# Notice of variation with introductory note

EPR/AP3439DZ/V002

# Whin Close Poultry Farm

This variation authorises the following changes:

Site plan - showing installation boundary as referred to in condition 2.2.1.

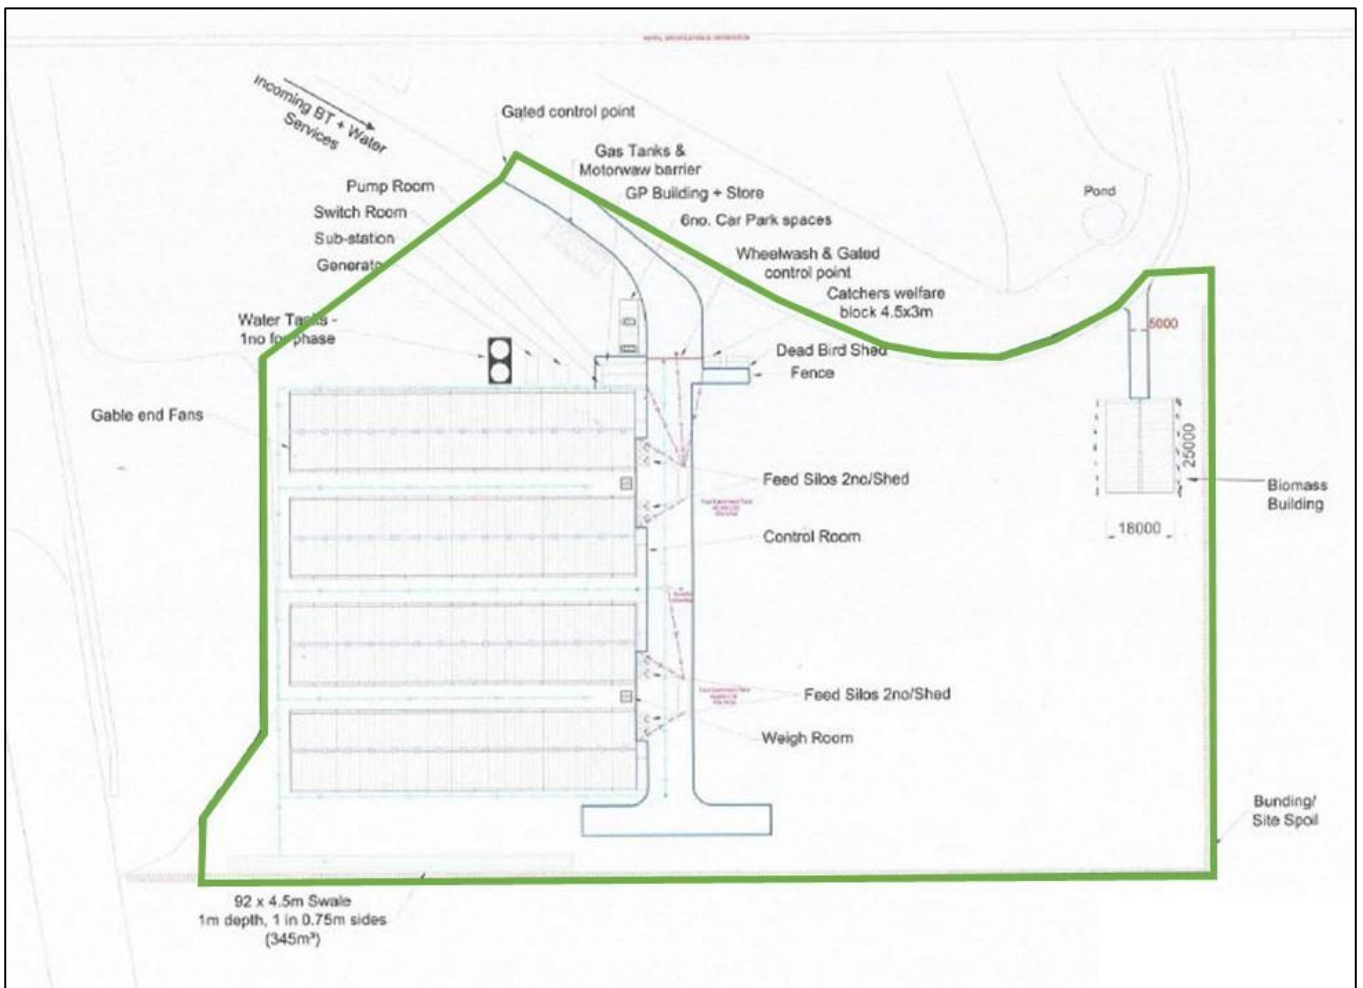
- The addition of one (Linka 1500) 1.047MWth biomass boiler.
- To increase the installation boundary.

| Status log of the permit                                     |                               |  |
|--|-------------------------------|--|
| Application EPR/AP3439DZ/V002                                | Duly made<br>24/10/17         | Application to add one biomass boiler along with associated fuel storage and to increase the installation boundary.  |

| <b>Table S3.1 Point source emissions to air – emission limits and monitoring requirements</b>   |                              |                  |                               |                         |                             |                                      |
|---|------------------------------|------------------|-------------------------------|-------------------------|-----------------------------|--------------------------------------|
| Emissions from one biomass boiler as shown on the site plan in schedule 7                       | Aggregated 1.047 MWth boiler | ---              | ---                           | ---                     | ---                         | ---                                  |
